09 June 2022

Bo Yin

Renewables Consultancy

## **Submissions in response to consultation paper on efficient reactive current access standards for inverter-based resources**

Figure .2 Q-Vt curve and Ip- Vt curve for a severe fault with  $V_F$  of 0.04 pu with 1 pu reactive current injection as a function of active current injection **for different X/R ratios**

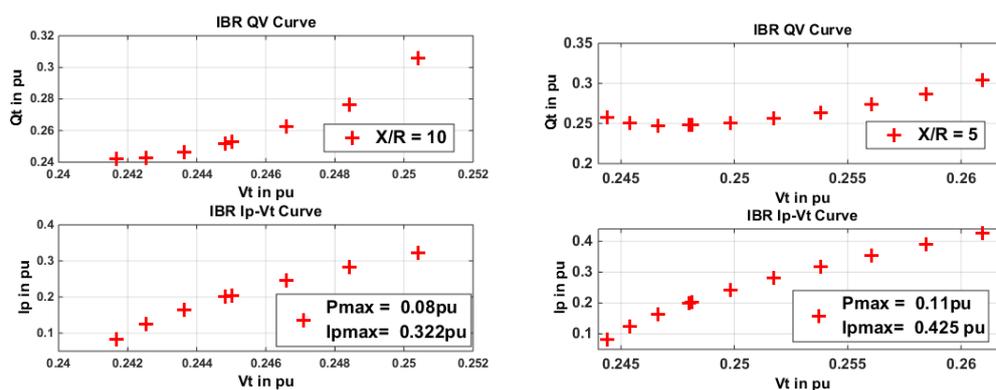
**Problem I** : The maximum active current which can be injected to grid during a sever fault is limited by power flow equation (3) not by the equipment's inherent limitations shown in Eq. (6).

Therefore, the requirement that reduction in the active-power component of current during a fault is permitted only in accordance with the equipment’s inherent limitations and the provision of the required reactive current defined in S 5.2.5.5 clause I (2)<sup>3</sup> is not possible in theory.

Figure .2 shows Q-Vt curve and Ip-Vt curve for a severe fault with  $V_F$  of 0.04 pu with 1 pu reactive current injection as a function of active current injection for different X/R ratios. The maximum allowed active powers during sever fault are 0.11pu in the X/R of 5 case and 0.08 pu in the X/R of 10 case. The maximum active current injected are 0.425 pu in the X/R of 5 case and 0.322 pu in the X/R of 10 case which are both **less than the equipment’s inherent limitations of 0.46 pu**.

- 1 pu reactive current injection (or more limited by converter thermal limit and injection rule defined in IBR) will boost voltage at IBR terminal to roughly X pu where X is internal impedance of plant for given X/R used.
- The active current and reactive current injection formula should be prescribed in a way that there is (are) a physical solution (solutions) available with respect to power flow Eq (1)-(3) for severe fault. Otherwise, there is no equilibrium which can be achieved for a severe fault. **This should be aware by both IBR OEMS and policy makers.**

Figure .3 Q-Vt curve and Ip- Vt curve for a severe fault with  $V_F$  of 0.04 pu with 1 pu reactive current injection as a function of active current injection **for different retained voltages at PCC**

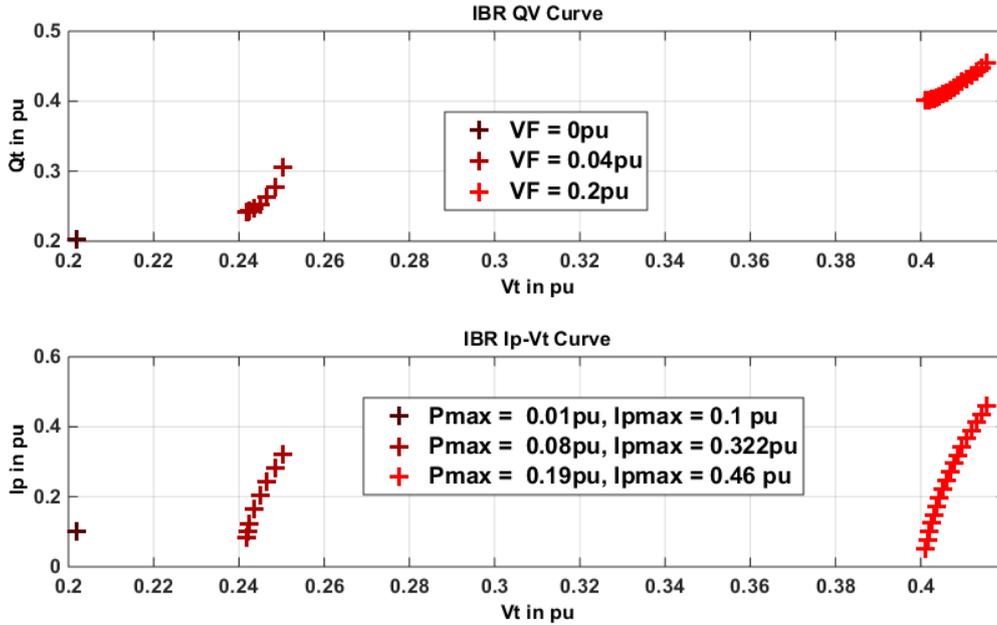
Figure .3 shows Q-Vt curve and Ip-Vt curve for a fault with different retained voltage  $V_F$  at PCC with 1 pu reactive current injection as a function of active current injection. The example again confirms that the possible active current injection in a severe fault is limited by power flow equation.

Figure .4 Q-Vt curve and Ip & Iq- Vt curve for a shallow fault with VF of 0.65 pu with Kfactor of 4 and Vth of 0.95 pu for reactive current injection as a function of active power injection

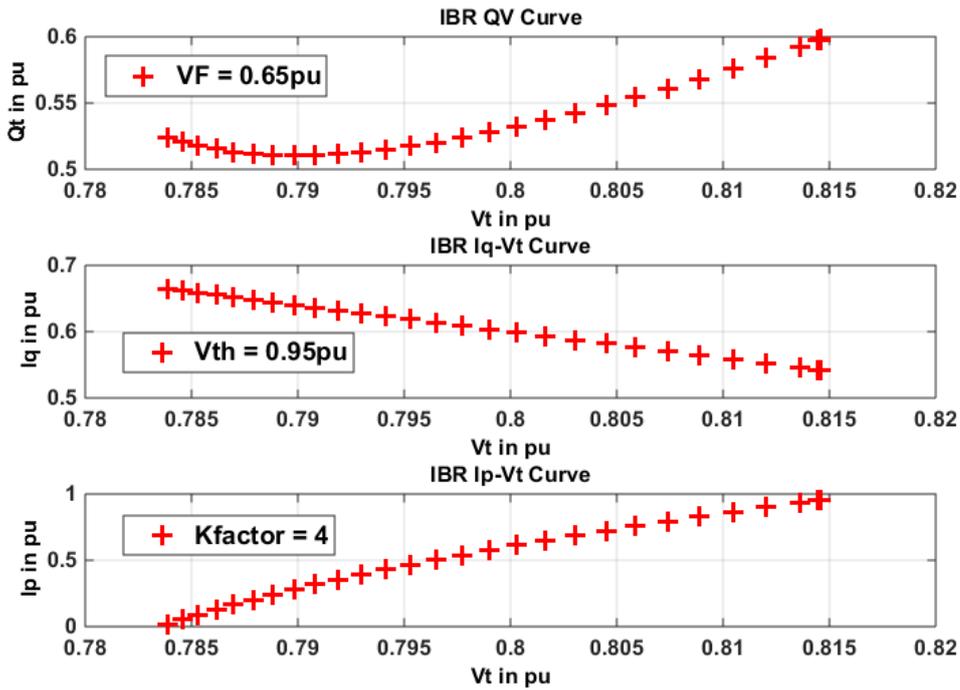
This has been illustrated in Example 3. In example 3, for moderate fault with a retained voltage of 0.65pu at PCC, it will require high Kfactor<sup>5</sup> of 4 and Vth of 0.95 pu) to achieve 0.5 pu reactive current injection for MAS with reactive current injection commence at 0.9 pu.

According to this requirement, it requires full reactive current injection for minimum detVpcc of 0.25pu (corresponding to VF of 0.65pu) with assumption that reactive current response is to commence when the voltage is 90%. As turbine see much higher voltage with 20% internal plant impedance, it needs a very high Kfactor and Vth to obtain 0.5 pu reactive current with high terminal voltage.

With Kfactor =4 and Vth=0.95, it is possible to inject 0.5 pu reactive current with terminal voltage above 0.75pu.

- ✓ With appearance of the internal impedance, it is difficult to mean minimum reactive current capability standard specified at PCC especially for plant with high internal impedance.

Figure .5 Q-Vt curve and Ip & Iq- Vt curve for a shallow fault with VF of 0.8 pu with Kfactor of 4 and Vth of 0.95 pu for reactive current injection as a function of active power injection

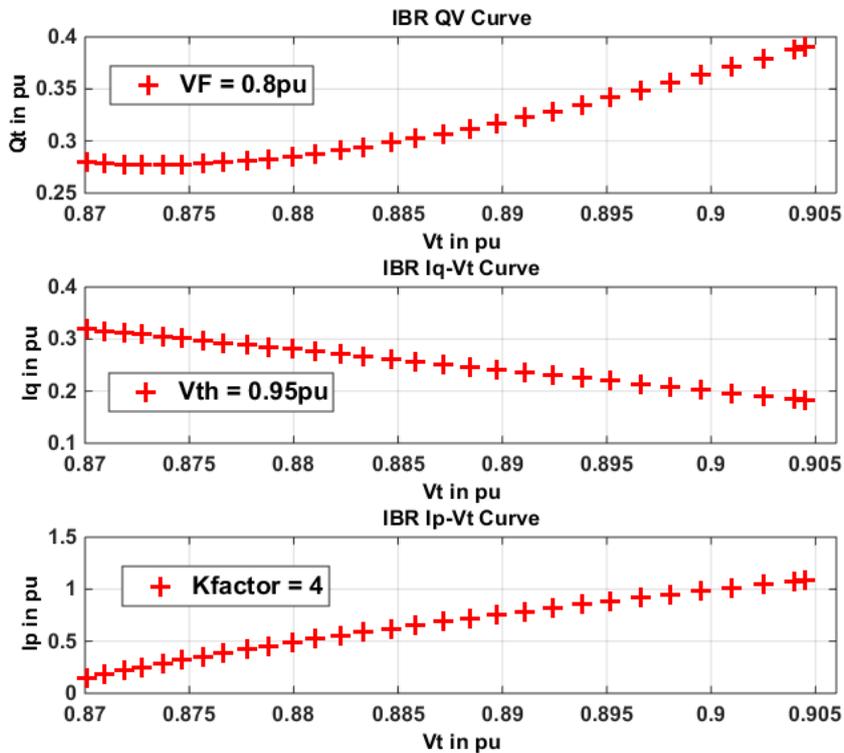
With Vth and Kfactor settings fulfilling MAS in a moderate fault, IBRs will see terminal voltage higher than 0.9 pu when retained voltage at PCC is 0.8 pu as seen in example 4. As a result, for a shallow fault at PCC, converter terminal voltage might not drop below LVRT threshold voltage and thus there is no reactive current injection from converter at all.

This problem becomes even worse in a larger internal plant impedance case.
